Project Title: PRICHARD SUBDIVISION **Building Permit #:** _____ **Hydrology File #:** _____

RE: **Prichard Subdivision**
Tr C2A2 Sauvignon
Grading Plan Stamp Date: 11/30/18
Drainage File: E22D007H

Based on the submittal received on 12/3/18, the grading plan and drainage report cannot be approved until the following are corrected:

UPLAND BASIN MAP

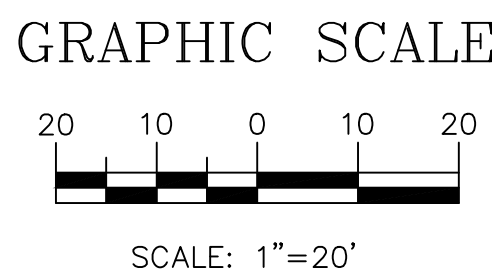
- a. Delineation of off-site contributing watersheds and/or drainage basins on City of Albuquerque Ortho-Topo Area Maps or equivalent mapping at a preferable scale of 1" = 200' or 1" = 500'. Watershed and Basin designations shall match those used in the hydrology calculations. **no offsite per map on plan**
